Wisconsin Department of Transportation

Proposal #64: 1500-37-74, WISC 2019 210
Waldo Blvd, City of Manitowoc
14th Street – 8th Street
USH 10
Manitowoc County

This is Addendum No. 01, which provides for the following:

ADDENDUM NO. 01

Addendum No. 01
ID 4570-12-71/72
Revised Sheet 144
March 6, 2019

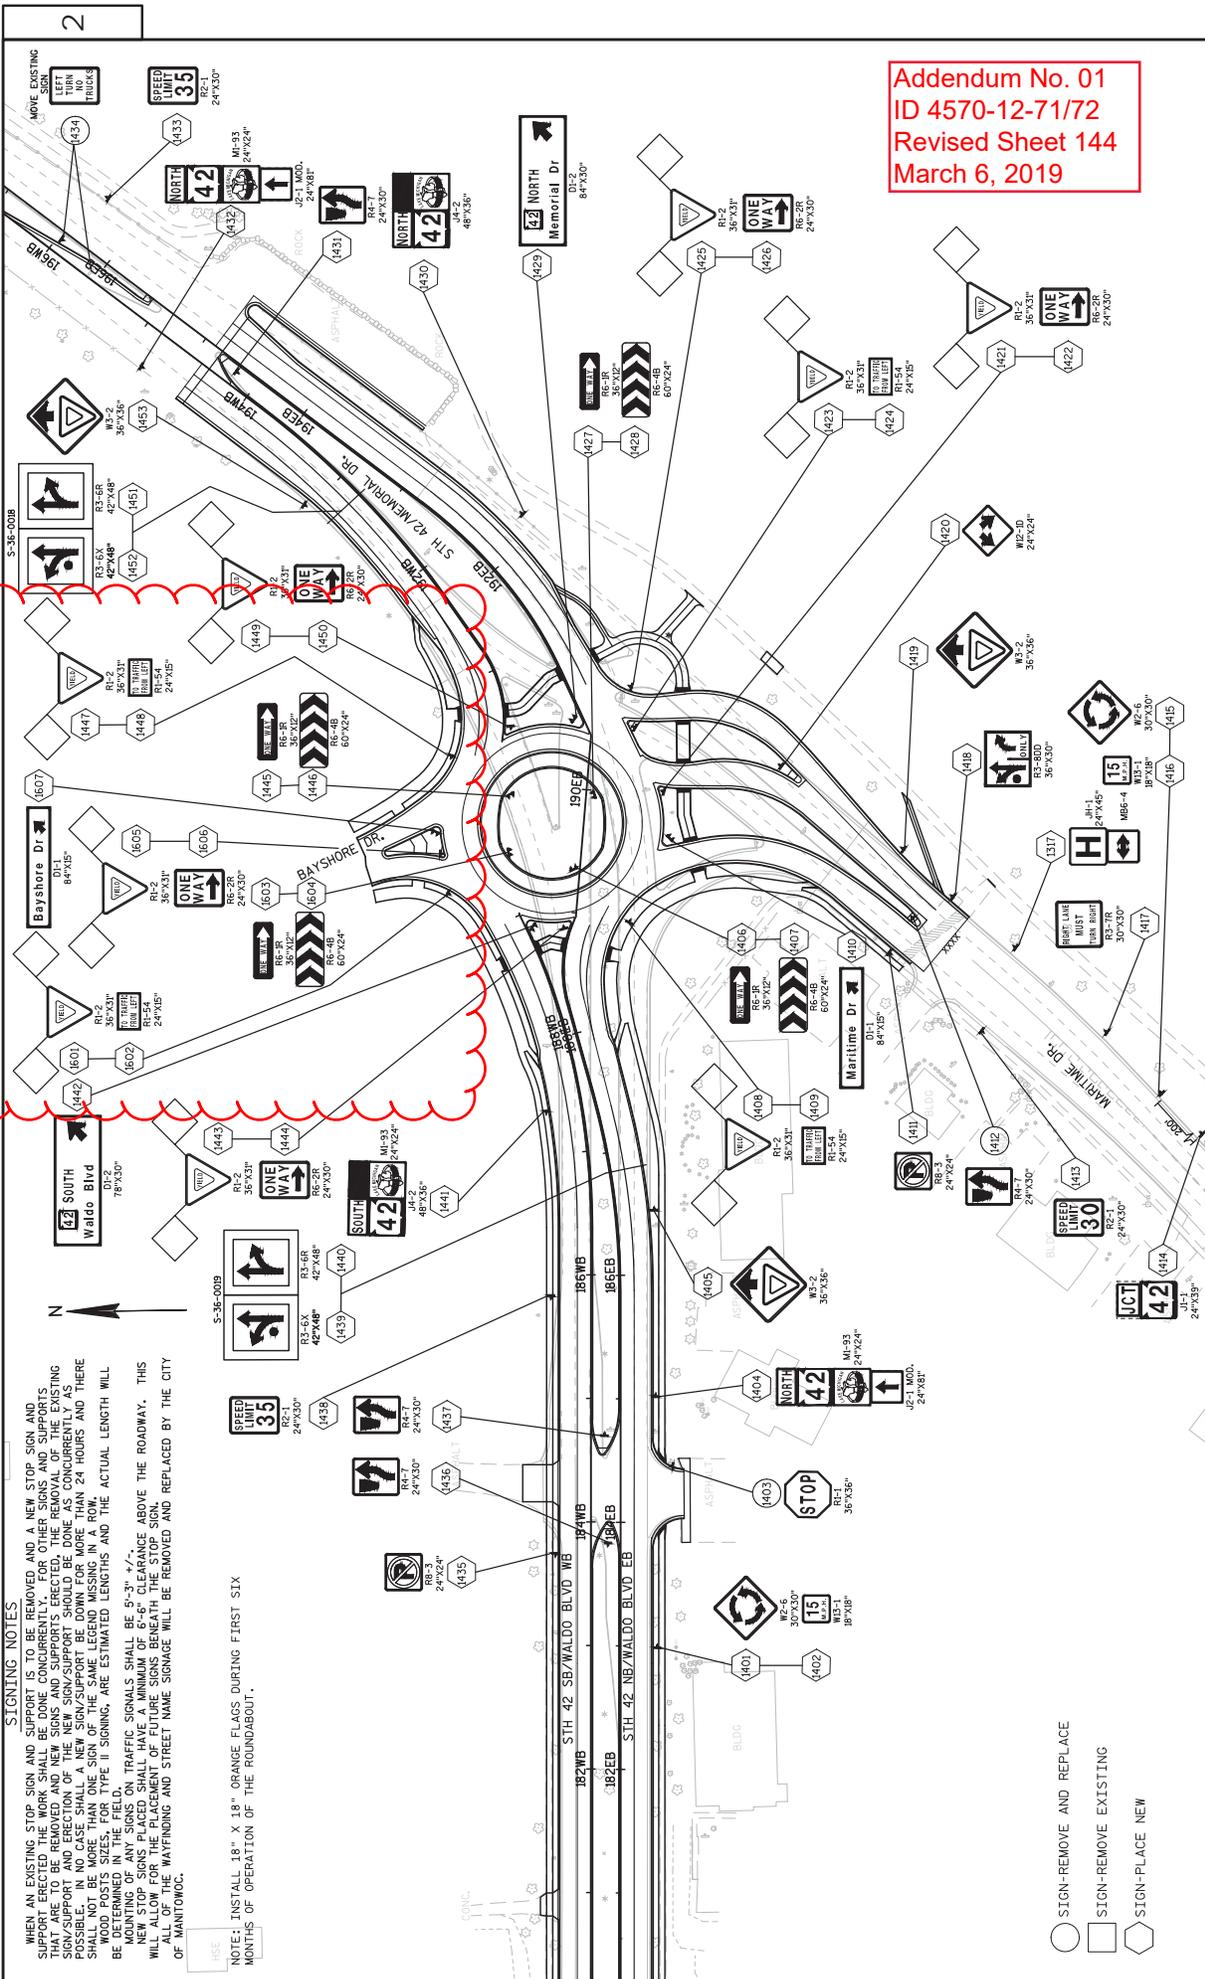
Revised Plan Sheets	
Plan Sheet	Plan Sheet Title (brief description of changes to sheet)
144	Permanent Signing (Added signs)
